From: WELLS Russell D (AREVA NP INC) [Russell.Wells@areva.com]
Sent: Friday, March 27, 2009 5:41 PM
To: Getachew Tesfaye
Cc: Pederson Ronda M (AREVA NP INC); BENNETT Kathy A (OFR) (AREVA NP INC); DELANO Karen V (AREVA NP INC)
Subject: Response to U.S. EPR Design Certification Application RAI No. 145, FSAR Ch 9, Supplement 1
Attachments: RAI 145 Supplement 1 Response US EPR DC.pdf

Request for Additional Information No. 145, Supplement 1

U. S. EPR Standard Design Certification
AREVA NP Inc.
Docket No. 52-020
SRP Section: 09.05.08 - Emergency Diesel Engine Combustion Air Intake and Exhaust System
Application Section: 9.5.8

Figure 9.5.8-1—Emergency Diesel Generator Air Intake and Exhaust System

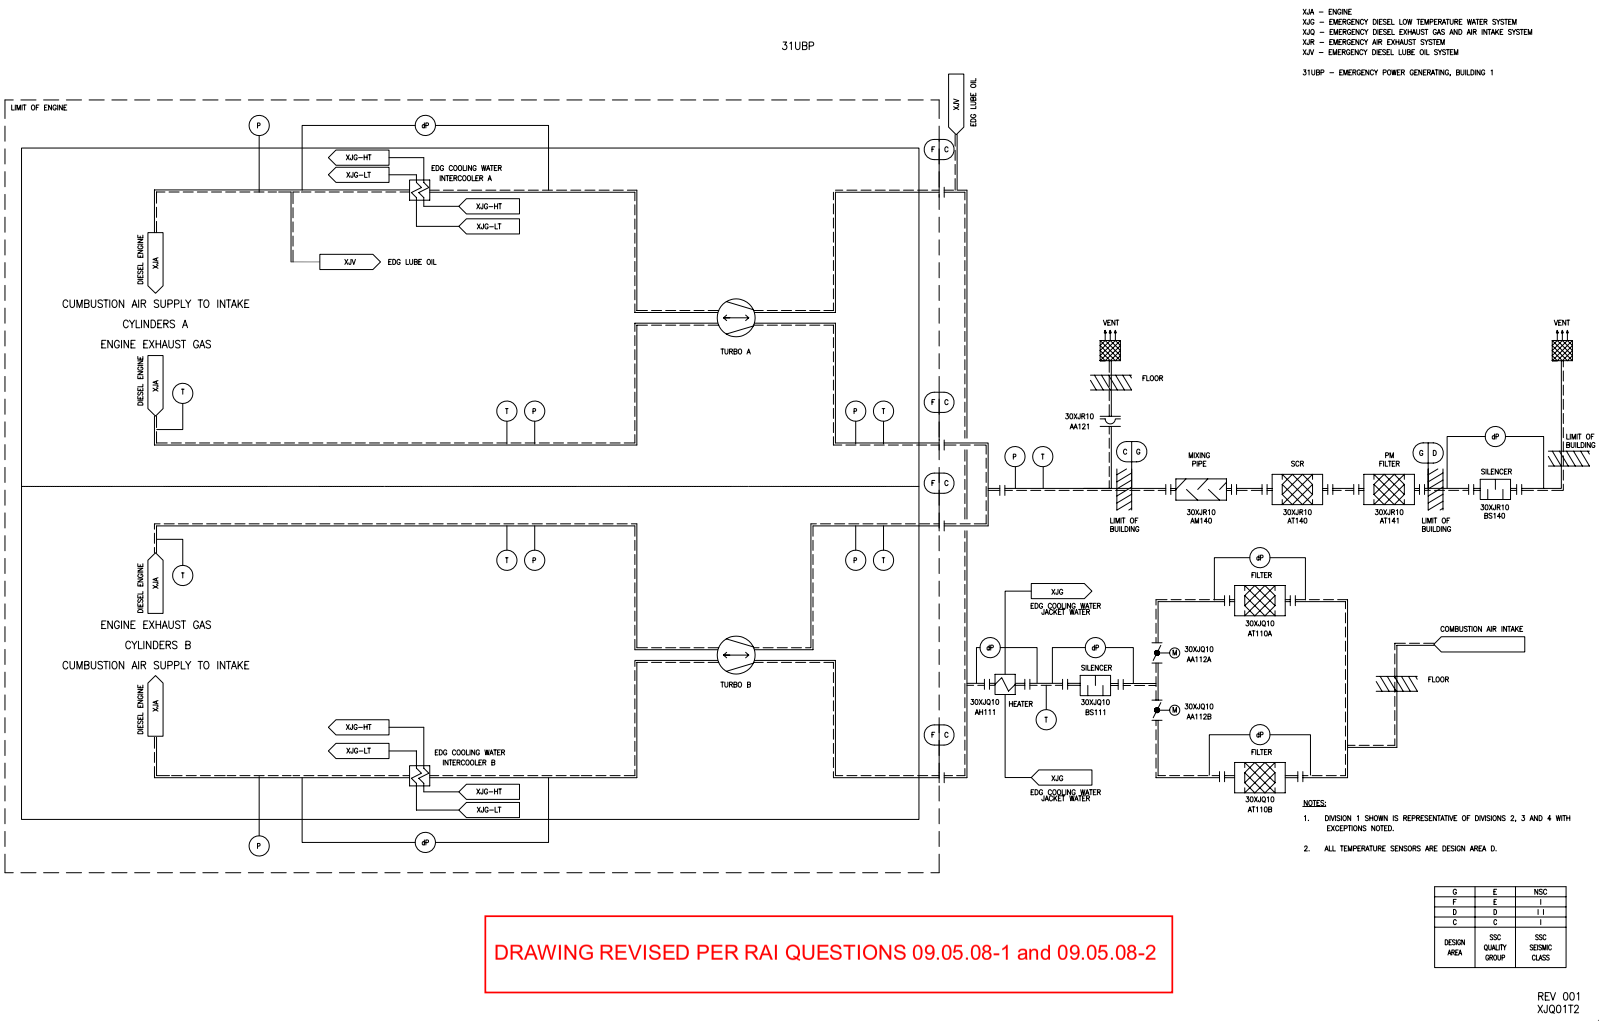
FSAR Tier 2, Figure 9.5.8-1, "Emergency Diesel Generator Air Intake and Exhaust System," shows the safety-related (Quality Group C) exhaust stack and vent and the non safety related (Quality Group D) exhaust silencer and vent. The applicant has not shown a concise location of the interface between Quality Group D and Quality Group C on Figure 9.5.8-1.

a. The applicant needs to clearly define the interface. If the interface is inside the Emergency Power Generator Building (EPGB), verify that a safe shutdown earthquake (SSE) will not cause any portion of the Quality Group D piping to break inside the EPGB.

b. Explain whether any portion of the safety-related (Quality Group C) exhaust stack and vent is outside the EPGB. If any portion is outside the EPGB, explain meeting the requirements of GDC 2 for that portion.

c. Show the boundary of the EPGB to outside.

FSAR Section, "9.5.8.2.2, "Component Description," states that the diesel generator air intake and exhaust system (DGAIES) has exhaust emission equipment to control exhaust emissions. The exhaust emission equipment is not shown on Figure 9.5.8-1, "Emergency Diesel Generator Air Intake and Exhaust System." The applicant needs to designate the Quality Group and seismic class and show the component on Figure 9.5.8-1 to meet the guidelines of SRP Section 9.5.8.

FSAR Section 9.5.8.6, “Instrumentation Requirements,” states that monitoring the exhaust gas temperature is a safety-related function. Note 2 on Figure 9.5.8-1, “Emergency Diesel Generator Air Intake and Exhaust System,” indicates that temperature sensors are non safety-related. Explain the use of non safety related instrumentation for a safety related function.

FSAR Tier 2 Figure 9.5.8-1, “Emergency Diesel Generator Air Intake and Exhaust System,” shows interconnections between DGAIES and the EDG lubrication system. The purpose of this connection is not apparent and is not discussed in Tier 2 Section 9.5.8. Provide the purpose of this interconnection and the location in the FSAR of the discussion of its purpose.

a. The interface between the safety-related and non-safety-related structures, systems and components (SSC) of the diesel generator air intake and exhaust system (DGAIES) is at the penetration of the exterior wall of the emergency power generating building (EPGB). U.S. EPR FSAR Tier 2, Figure 9.5.8-1—Emergency Diesel Generator Air Intake and Exhaust System will be revised to show the interface boundary.

c. The interface boundary of the safety-related DGAIES SSC to the outside is shown on U.S. EPR FSAR Tier 2, Figure 9.5.8-1—Emergency Diesel Generator Air Intake and Exhaust System that will be revised in the response to Part a of Question 09.05.08-1.

The diesel generator air intake and exhaust system (DGAIES) is equipped with exhaust emissions control equipment for NO_X and preventative maintenance (PM) as required to meet emissions regulations for emergency diesel generators with a displacement of over 30 liters per cylinder. The emissions equipment is positioned downstream of the safety-related exhaust bypass stack and is located outside the Emergency Power Generating Building (EPGB). The emissions equipment is non-safety related and Non-Seismic and is assigned a quality group classification of Quality Group E. The silencer downstream of the emissions control equipment is located inside the EPGB; it is classified as Seismic Design Category II and is assigned a safety classification of Supplemented Grade (NS-AQ) and a quality group classification of Quality Group D. The exhaust emissions control equipment will be added to U.S. EPR FSAR Tier 2, Figure 9.5.8-1—Emergency Diesel Generator Air Intake and Exhaust System.

In addition to the preceding changes on the DGAIES exhaust path, several other changes to the DGAIES will be included on U.S. EPR FSAR Tier 2, Figure 9.5.8-1—Emergency Diesel Generator Air Intake and Exhaust System. An air heater, used to allow operation during extreme cold weather, will be added to the intake system. Clarification will also be added to show the intercooler high- and low-temperature cooling loops. The portions of the DGAIES that are part of the engine assembly are Seismic Category I but are beyond the ASME Section III boundary; therefore, the quality group classification for these SSC is Quality Group E.

The above changes will be reflected on U.S. EPR FSAR Tier 2, Figure 9.5.8-1—Emergency Diesel Generator Air Intake and Exhaust System that will be revised as part of the response to Question 09.05.08-1.

DRAWING REVISED PER RAI QUESTIONS 09.05.08-1 and 09.05.08-2
